# City of Alexandria, Virginia

## MEMORANDUM

**SUBJECT:** 2<sup>nd</sup> CONCEPT REVIEW OF 101 DUKE STREET  
BAR # 2020-00612

6 TH 6 GRADING SECTION  
 1/8" = 1'-0"

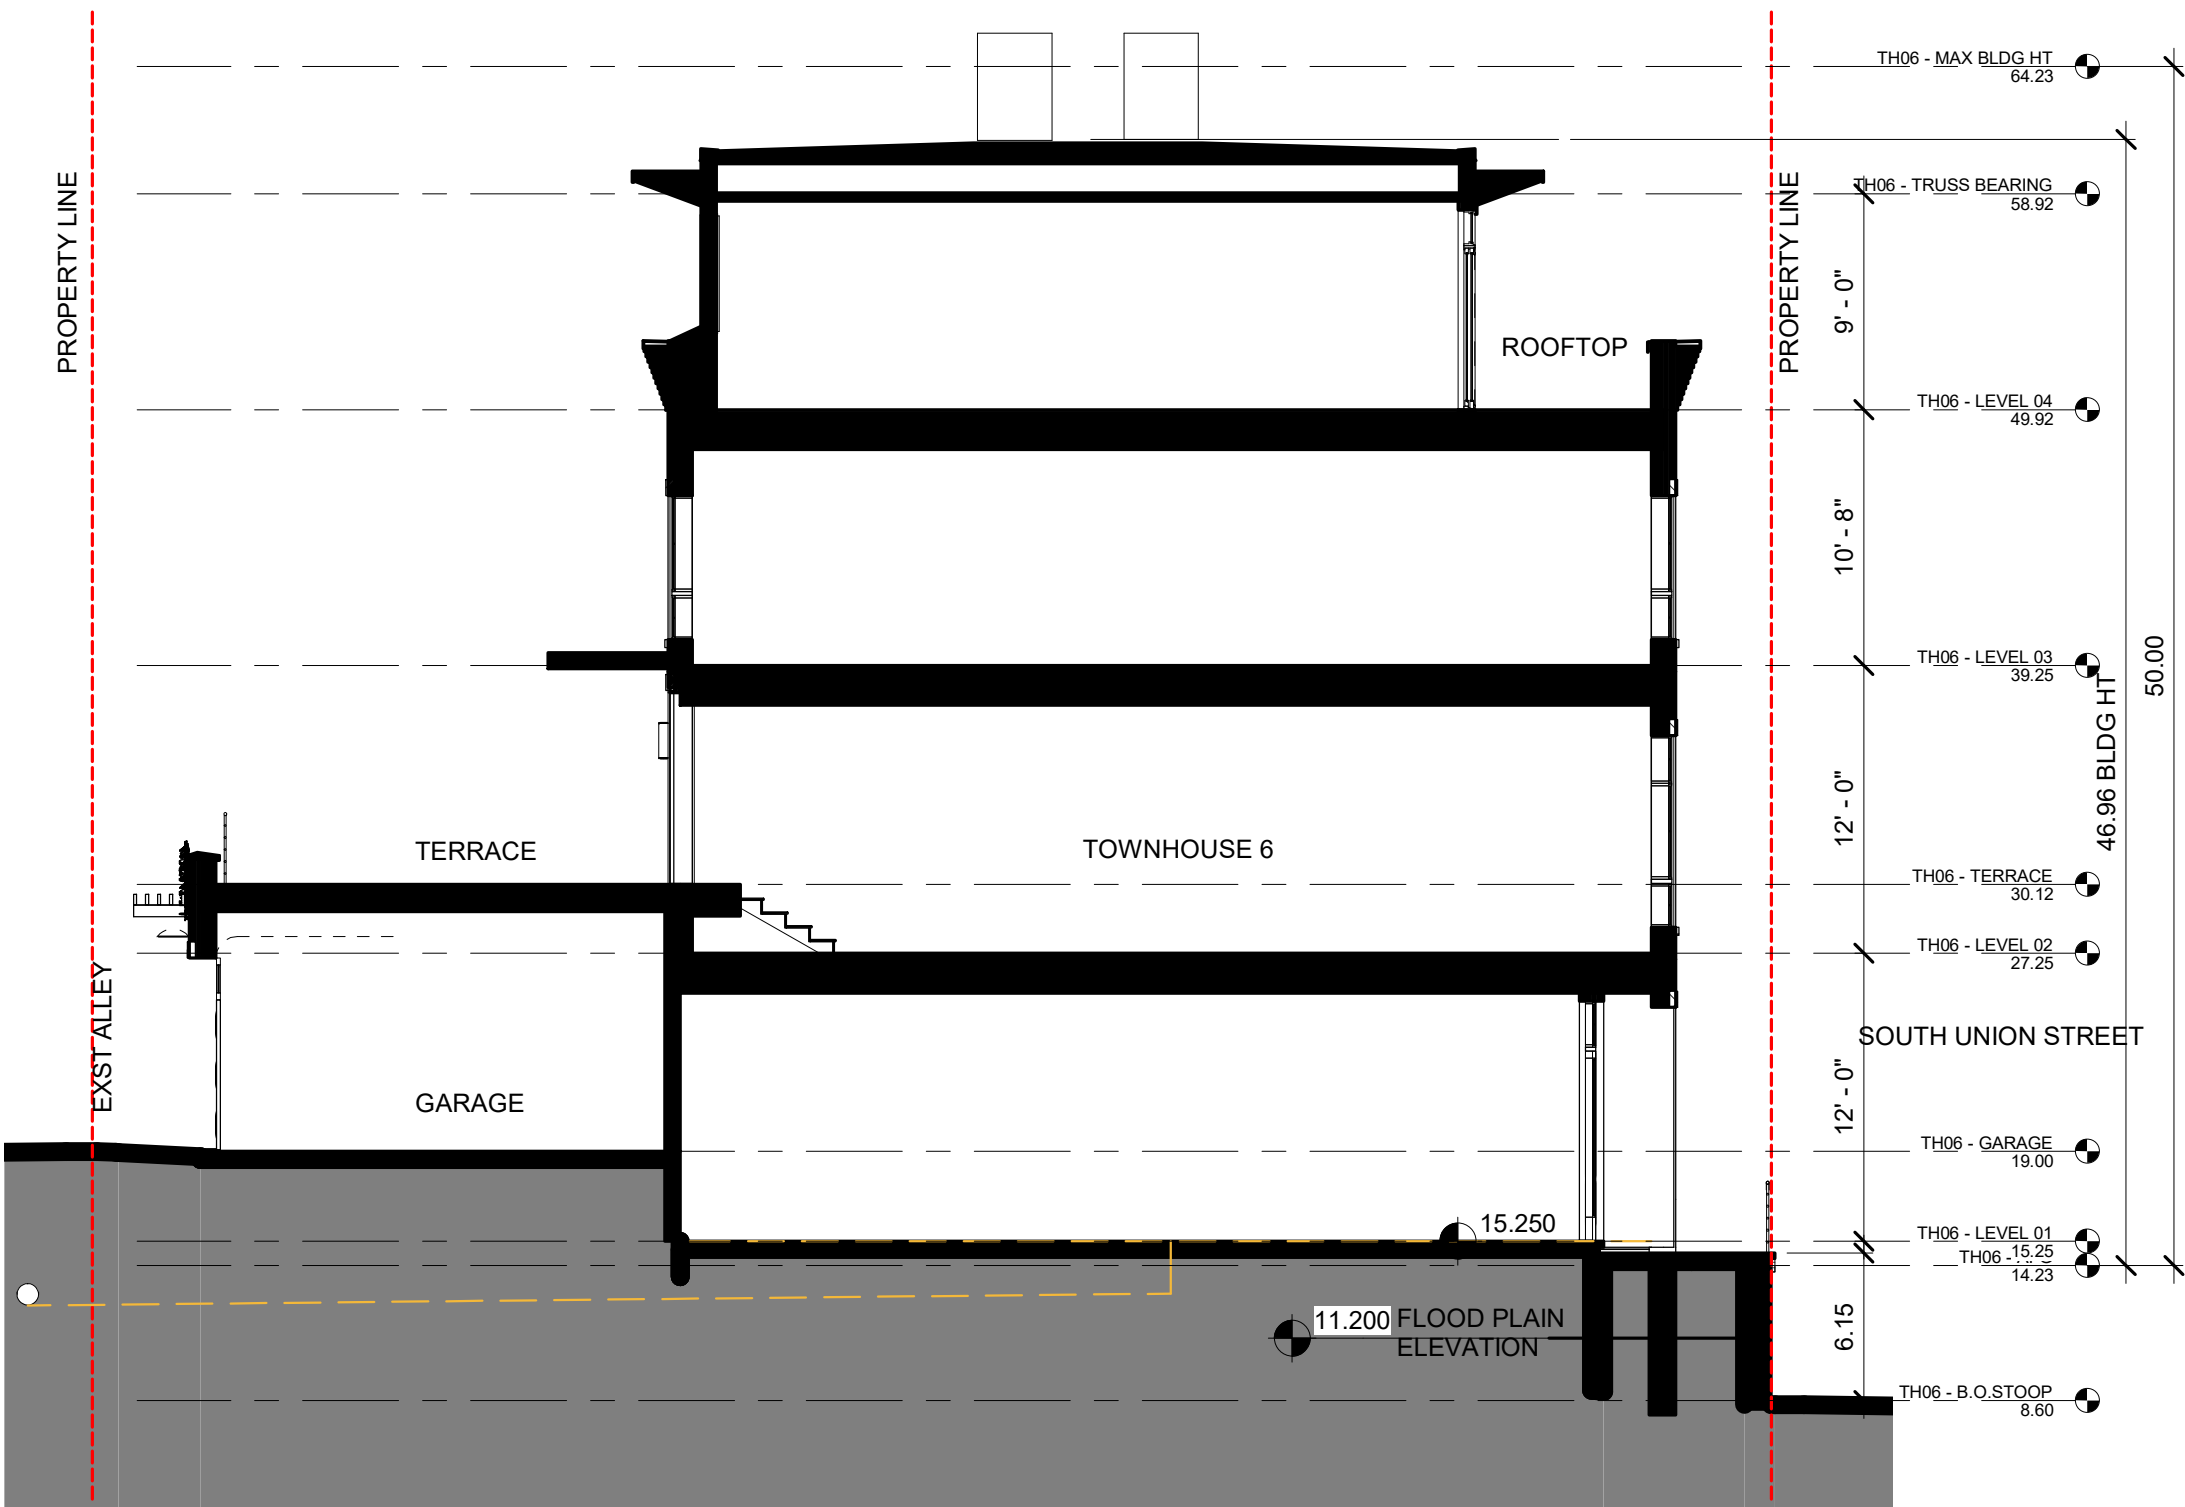
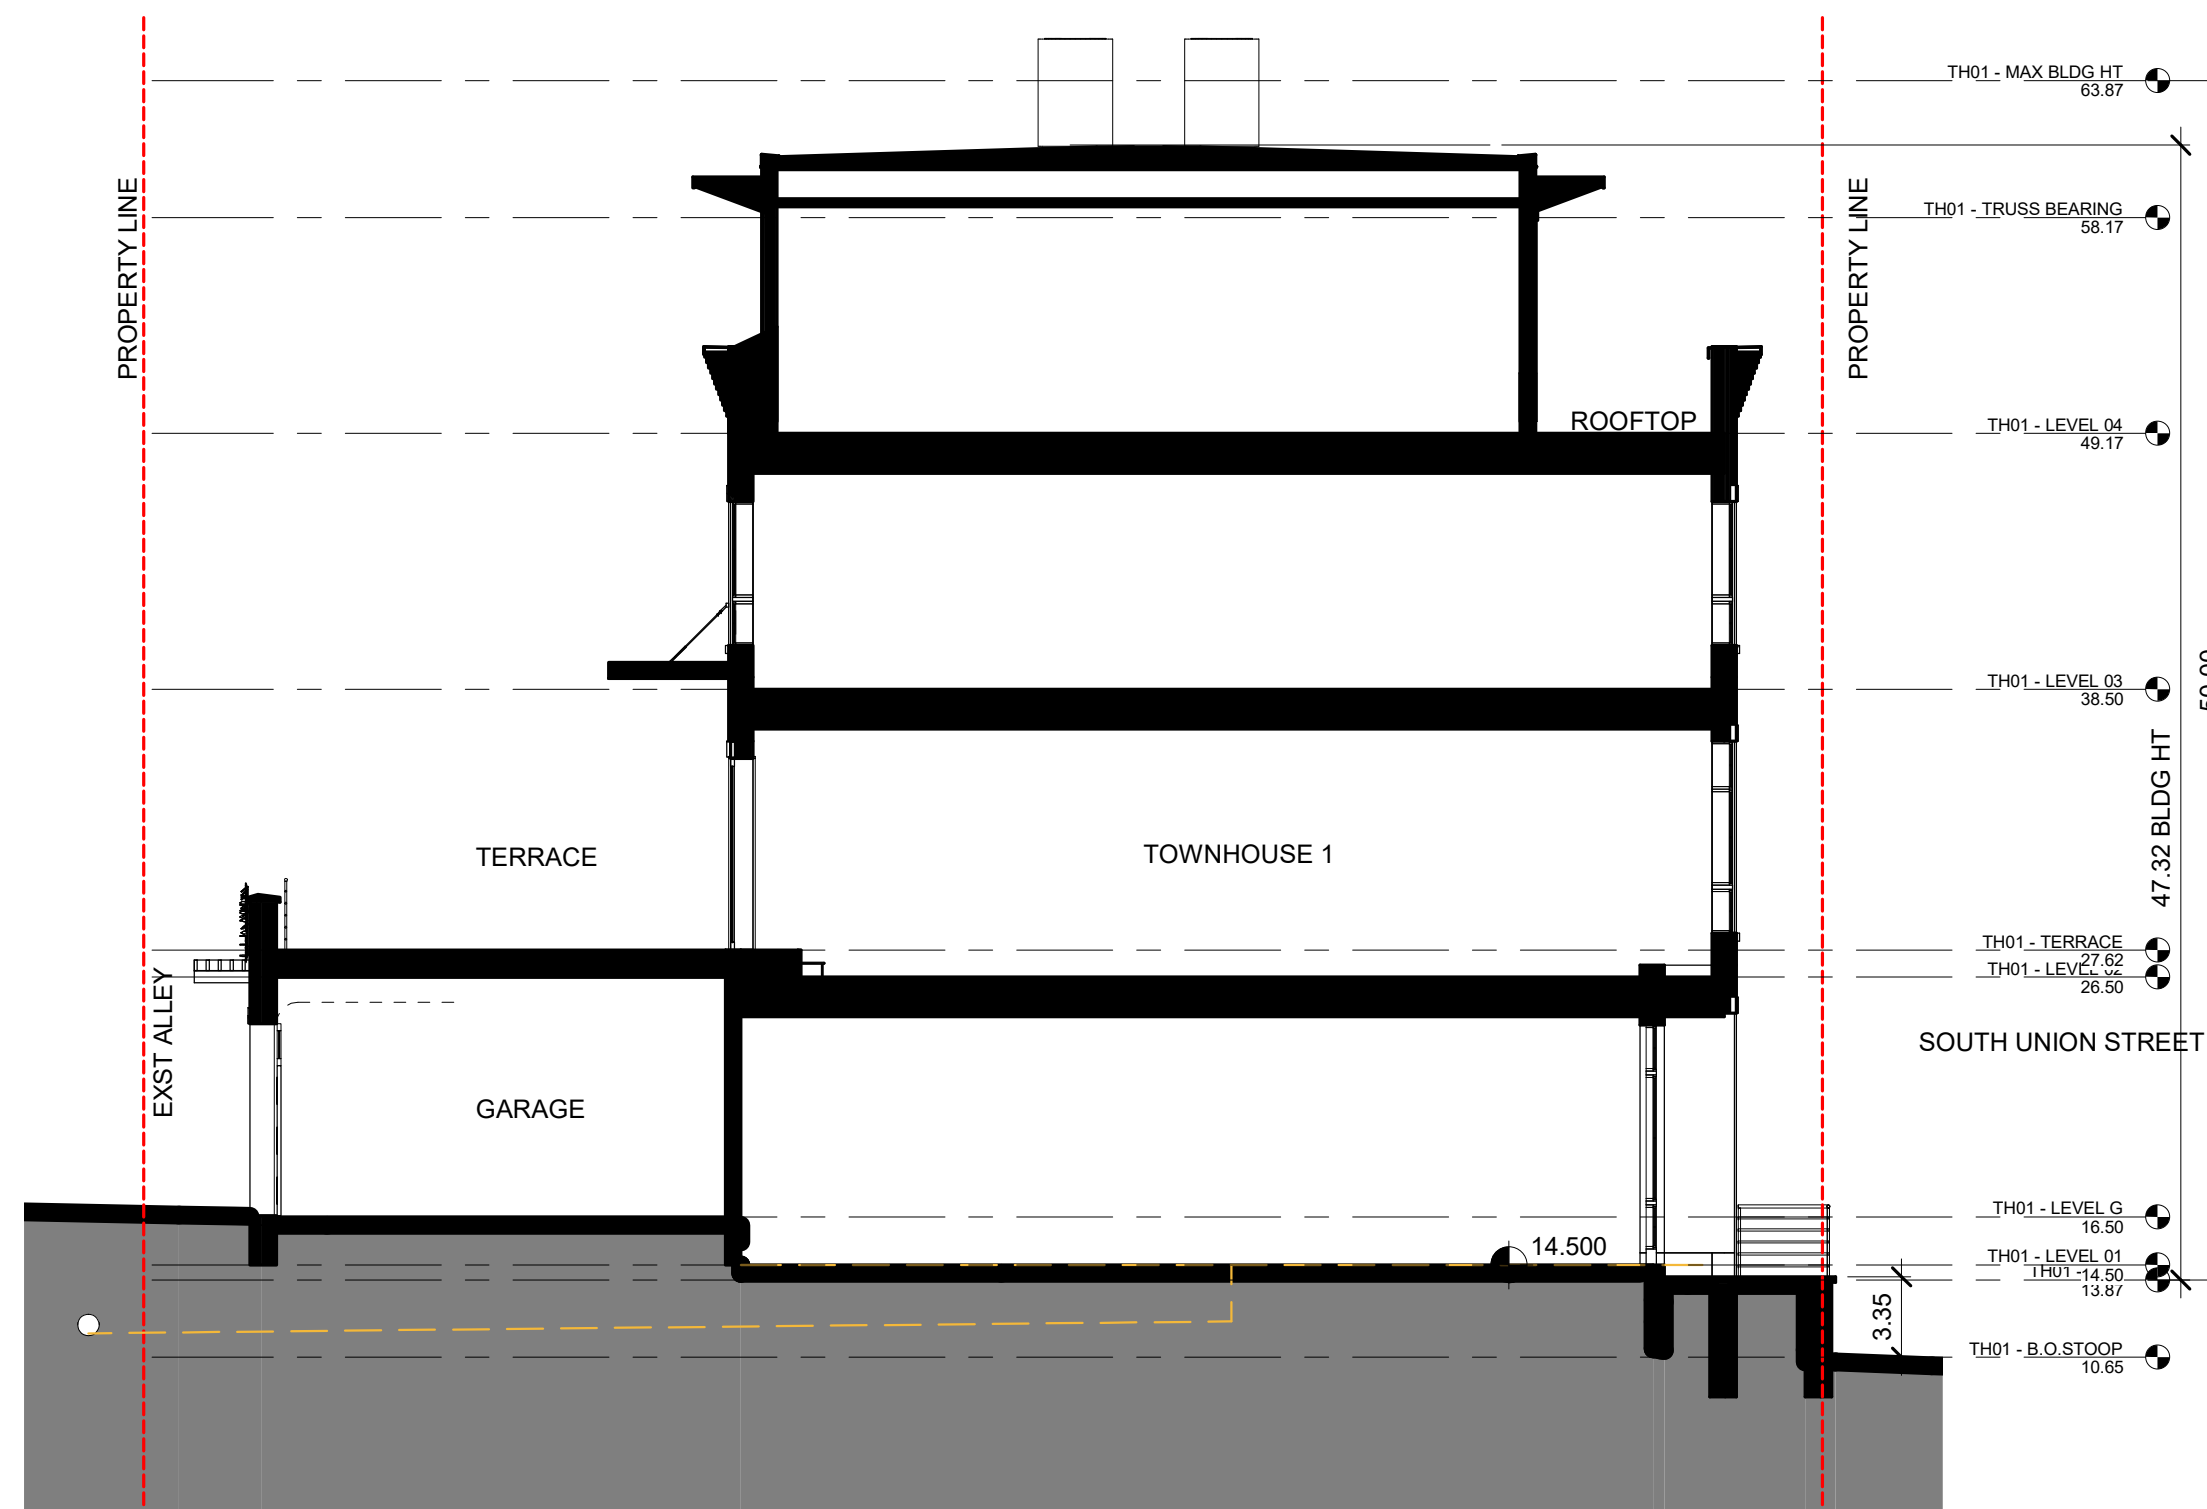
The previous design included entry stoops that ranged in height above the Union Street sidewalk from 5' at the lowest point to 7' at the highest point. As was discussed at the previous hearing, Union Street is a vibrant pedestrian oriented street and the height of the entries made for an uncomfortable relationship with the sidewalk. The design team was able to modify the interior design for the building so that the height of the stoop is not entirely driven by the elevation of the garages at the rear of the site. Unfortunately, there are other existing site conditions that require an elevated entry for each of the townhomes. In the revised design the applicant is now achieving entry stoop heights that range from 3' at the lowest point to 6' at the tallest. These create a streetscape that is much more friendly to pedestrians and brings the living spaces closer to the level of the sidewalk.

The current design for the entry stoops shows brick walls with brick pavers and metal rails. While the height of the stoops above the adjacent grade has improved since the last submission, the current design is still somewhat imposing and monolithic. This element represents an opportunity to create a part of the building that engages the sidewalk and helps to bring the scale of the building to a more pedestrian level. It is quite common throughout the historic district to find entry stoops in a variety of different designs. In some cases, where there is an English basement configuration, the entrance to the basement apartment is through stairs below the entry. Staff suggests that the applicant consider options for the design of the entry stair that are similar to those found throughout the historic district (Figure 12). In addition, it may help to provide a variation of approaches based on the height of the stoop which will further serve to break up the overall massing of the building.
